PPPO-02-10020228-22

**TRANSMITTAL OF THE REVISED 2016 UPDATE OF THE PADUCAH GASEOUS
DIFFUSION PLANT SITEWIDE GROUNDWATER FLOW MODEL,
DOE/LX/07-2415&D2/A1**

**2016 Update
of the Paducah Gaseous Diffusion Plant
Sitewide Groundwater Flow Model**

Date Issued—June 2022

Figure
3.10

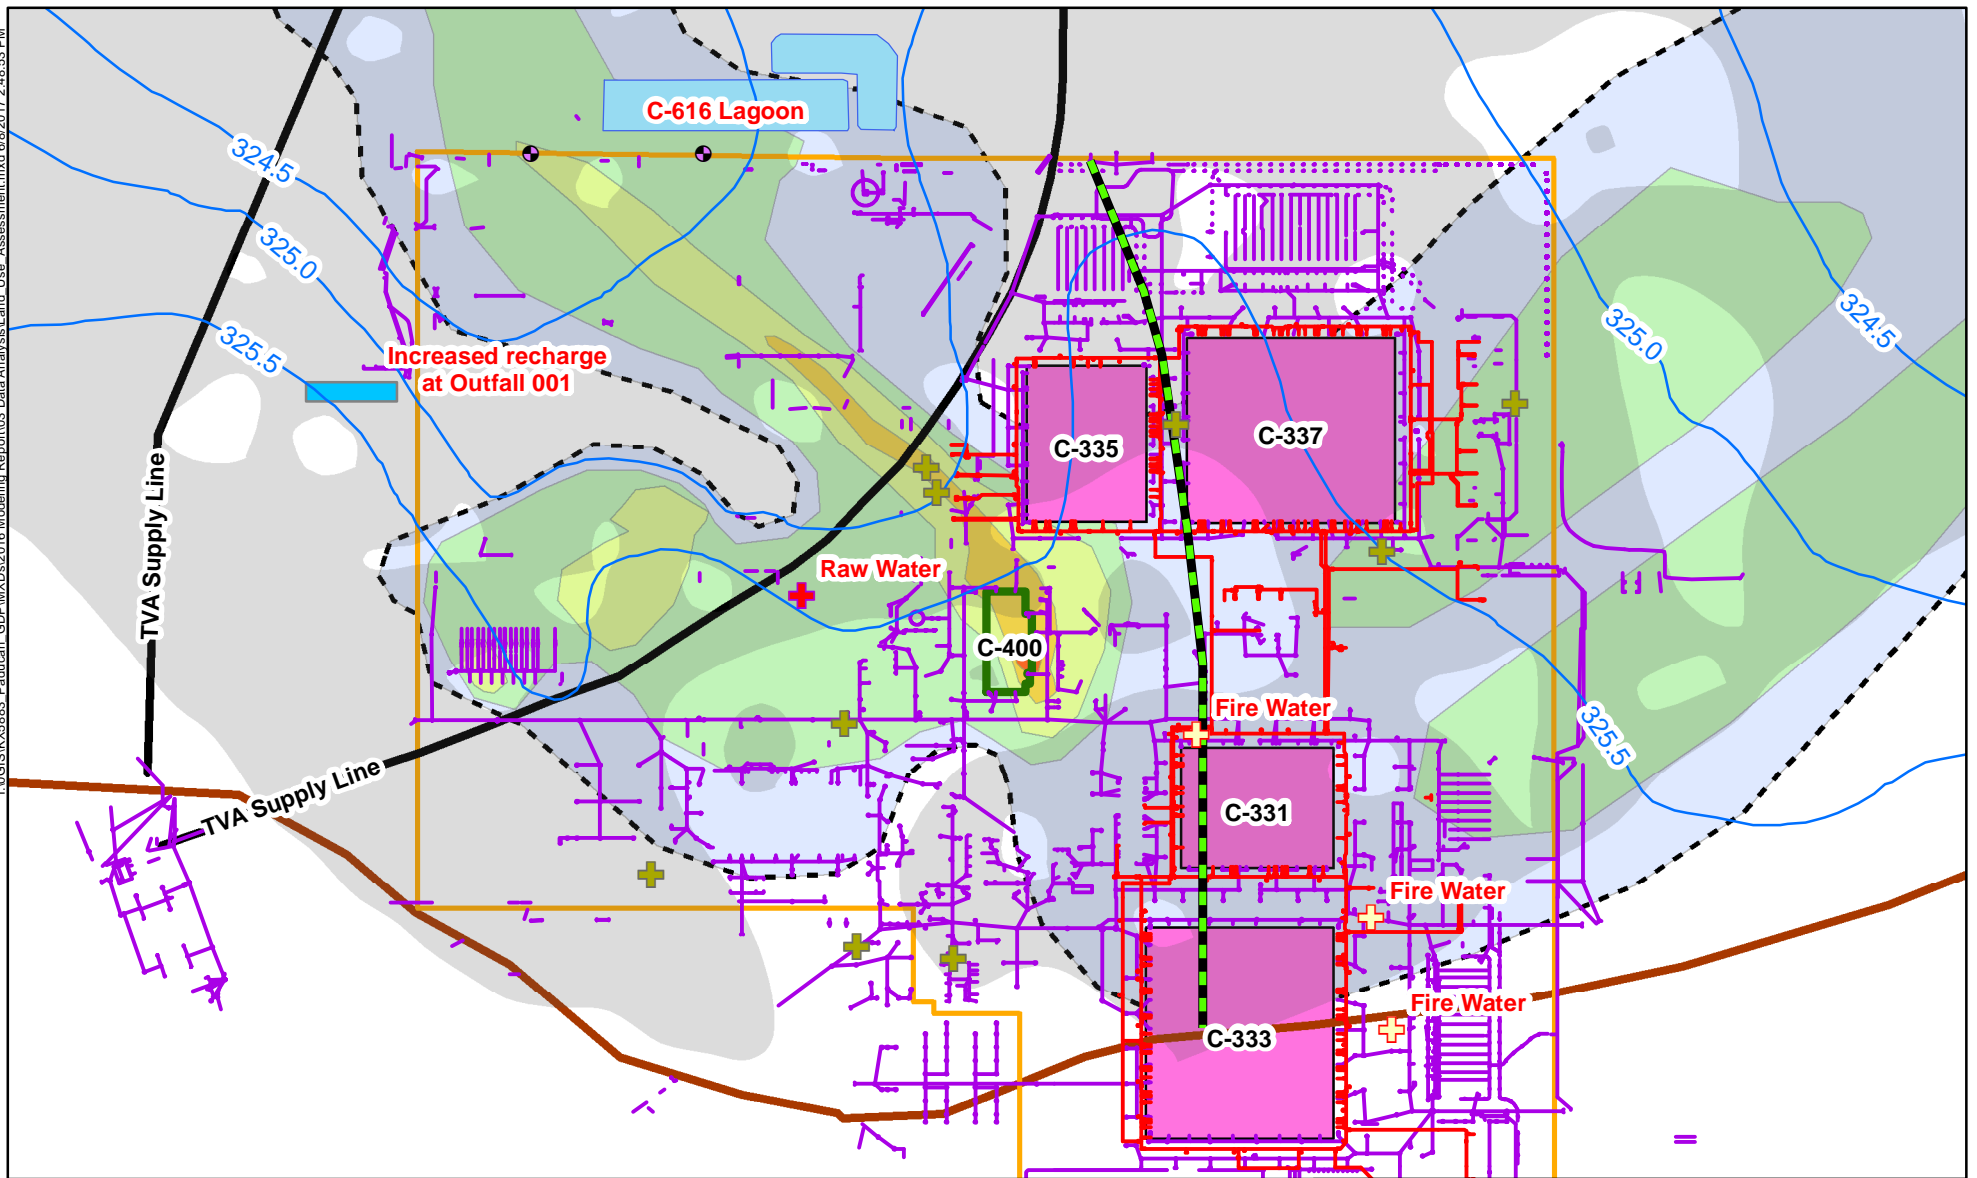
5. Pg-11: Figure 3.11 should be updated by incorporating the recent transect well data. Since the transect wells are located within the high recharge zone (Zone 24) with less than 2ft clay thickness, it is highly critical to include this data in the analysis.

b) Figure 3.11 - no Δ to document
but general comment regarding GW
divide at C-400.

3.14

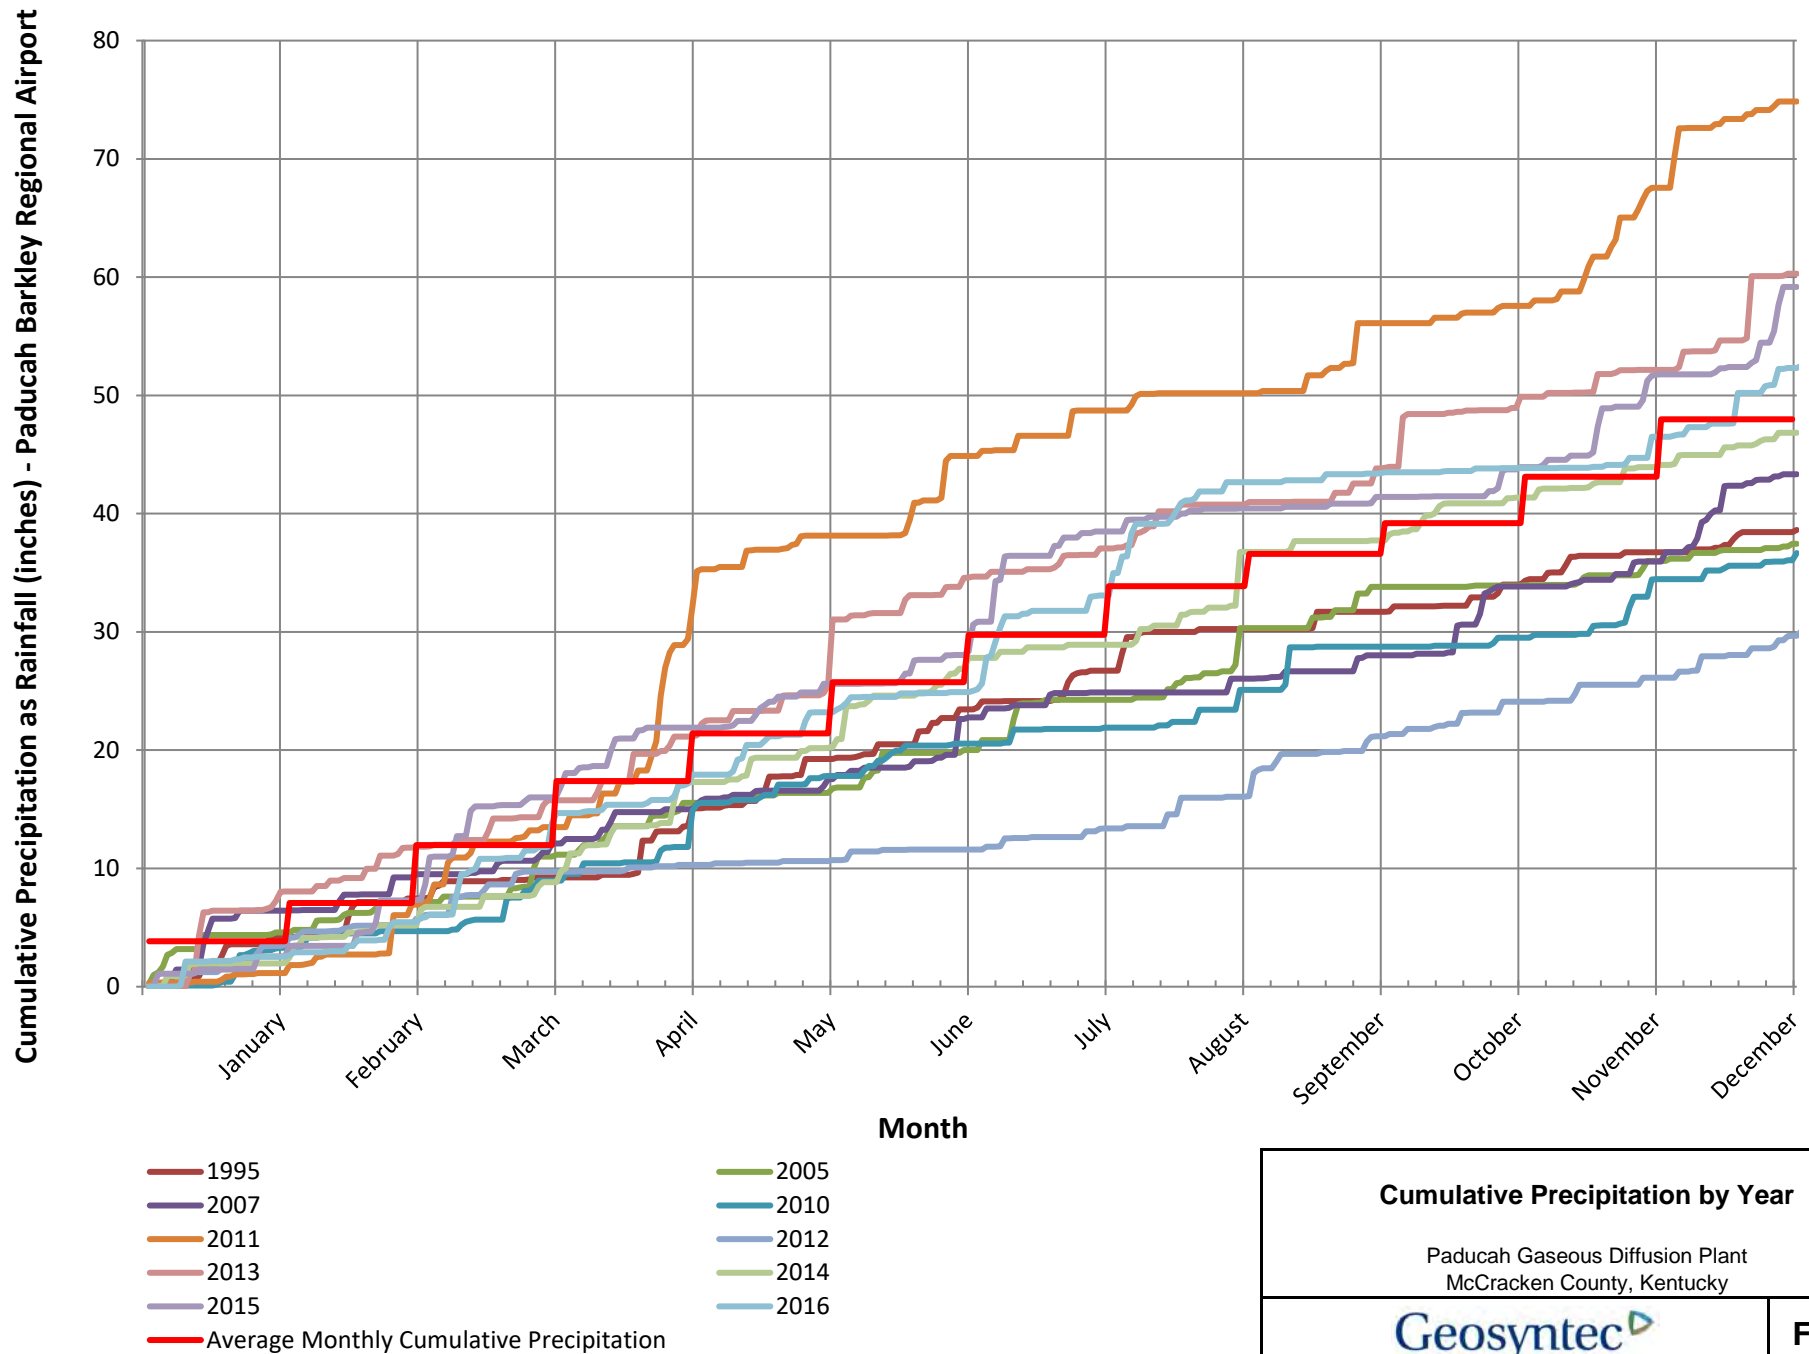
17) Text Regarding Figure 3.14 (p.41)
2nd PP
need clarification/additional text

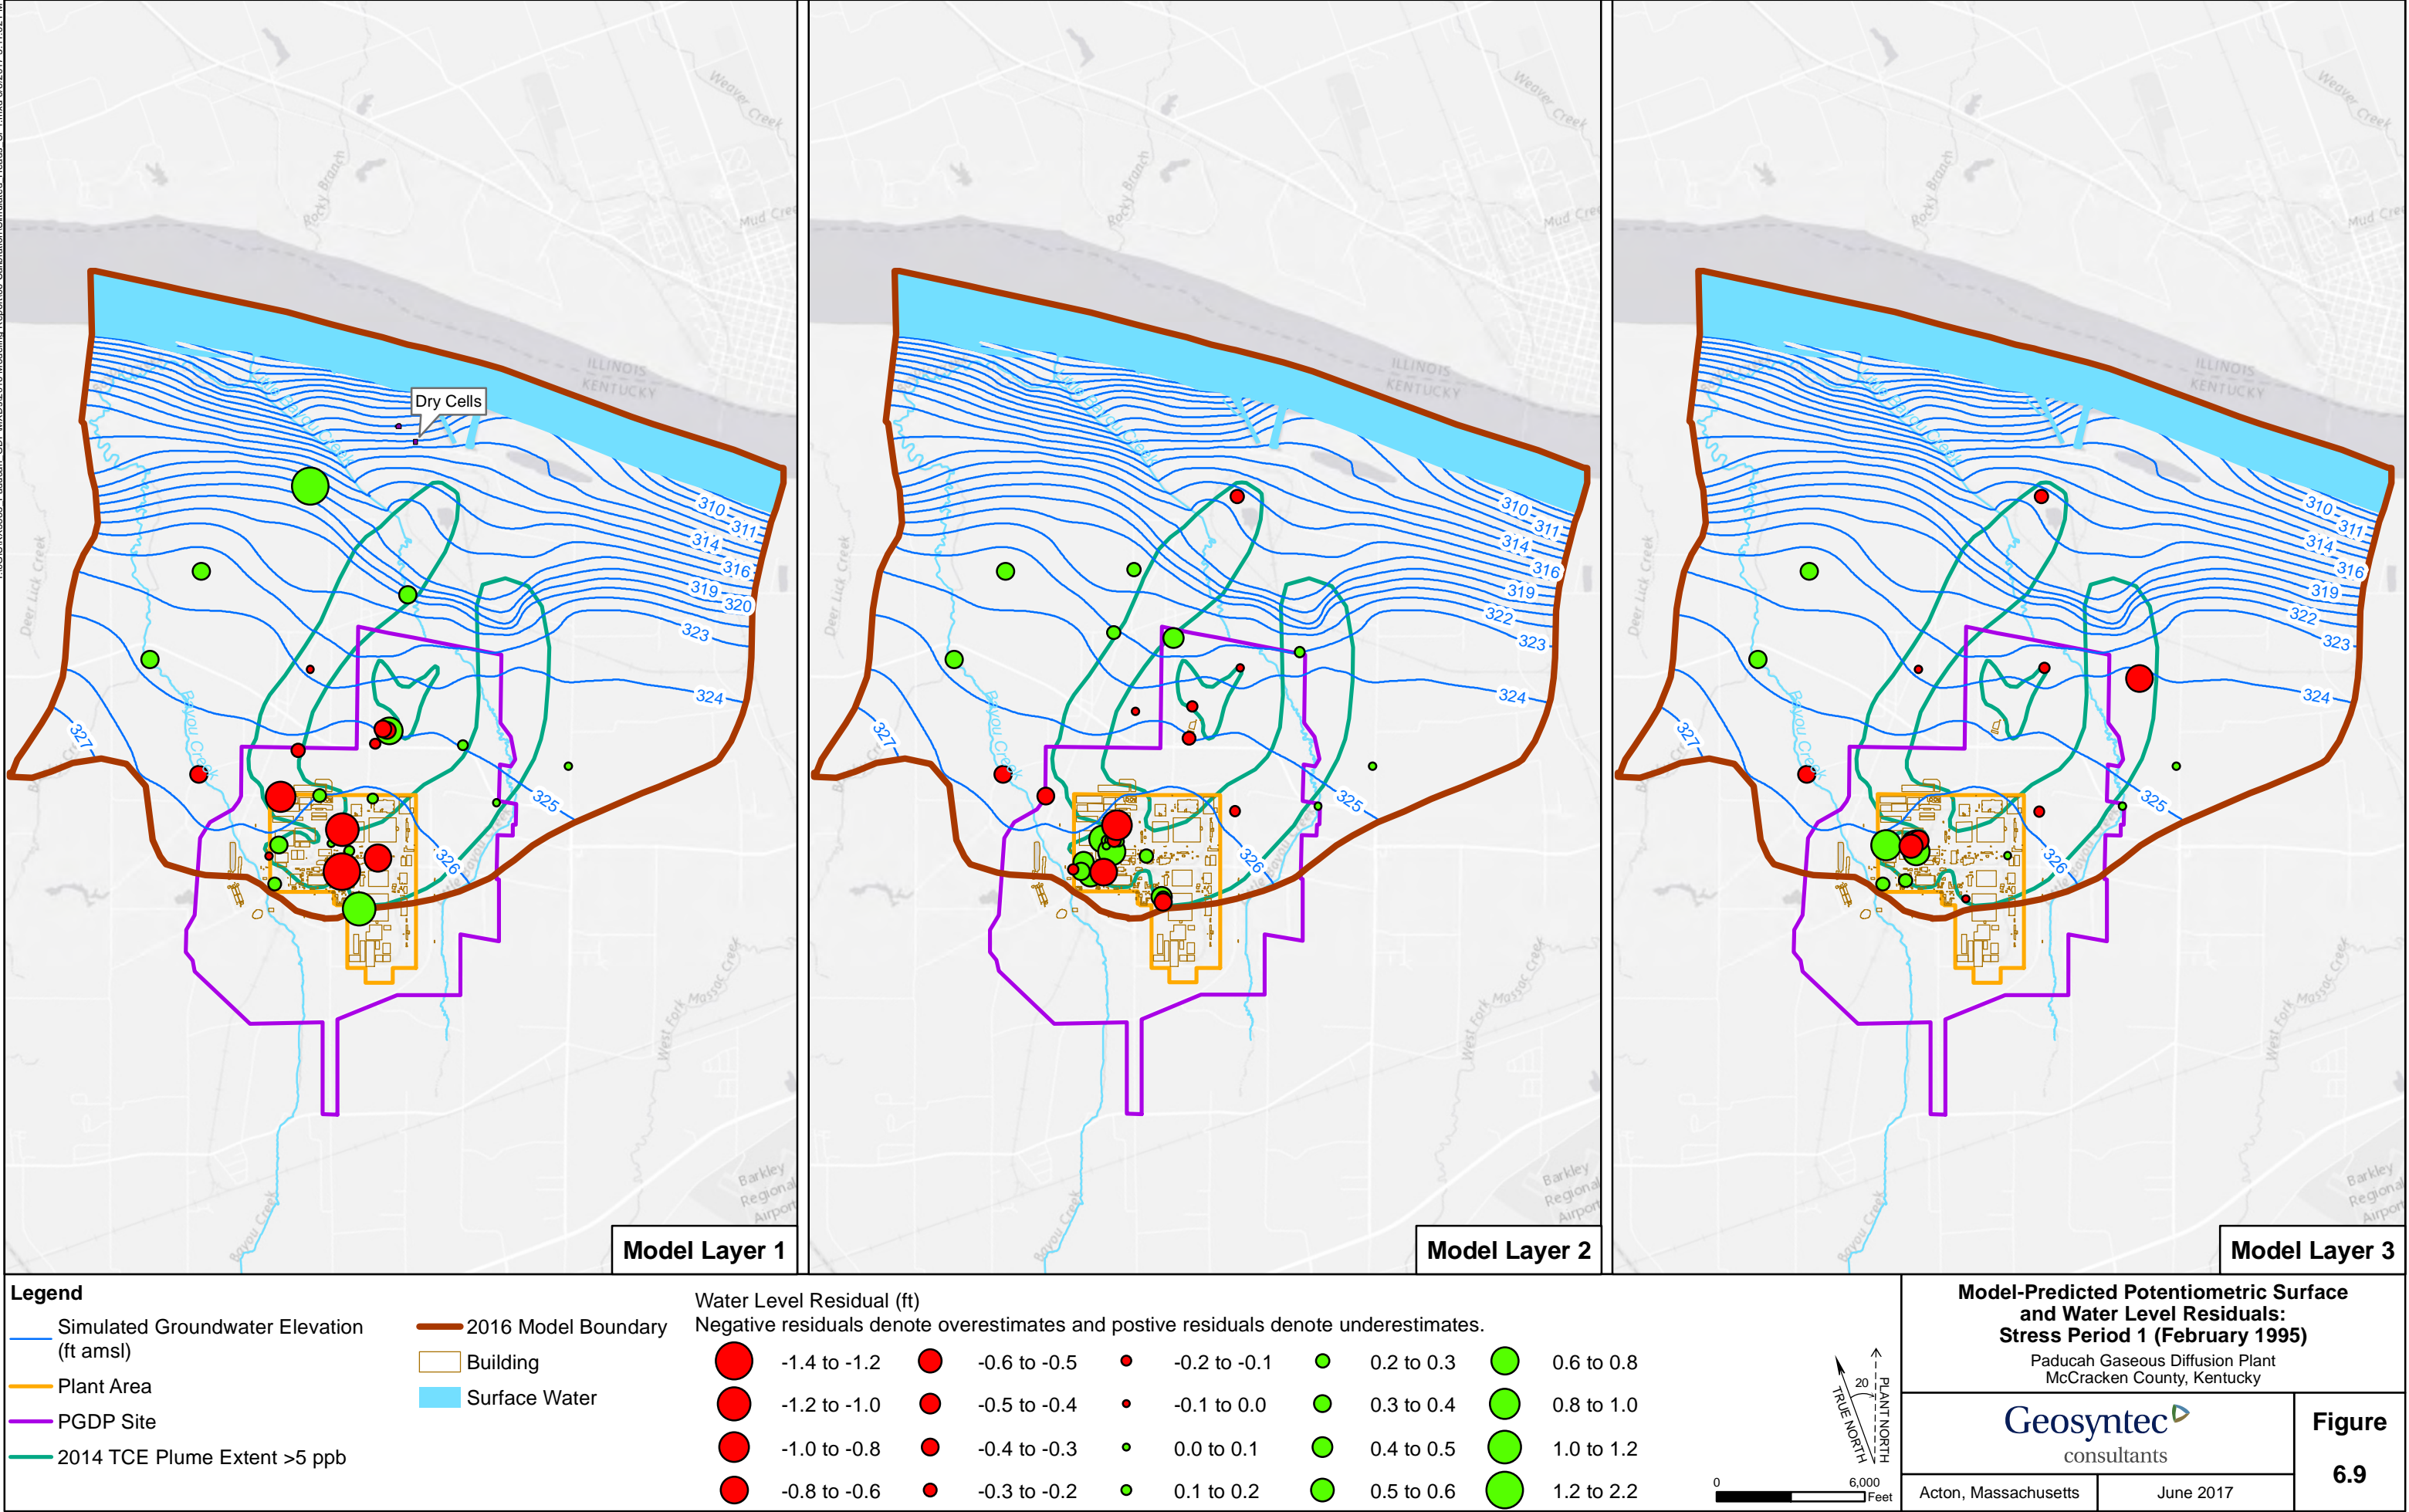
13. The residual values in Figures 6.9 and 6.10 show a number of calibration targets with high residual values inside the plant area. Some of the targets with higher residual errors are located near the southern boundary. Also, west of the C-400 building shows higher residual errors in all three layers. Changing the boundary values and/or types might help improve the calibration near the southern boundary.
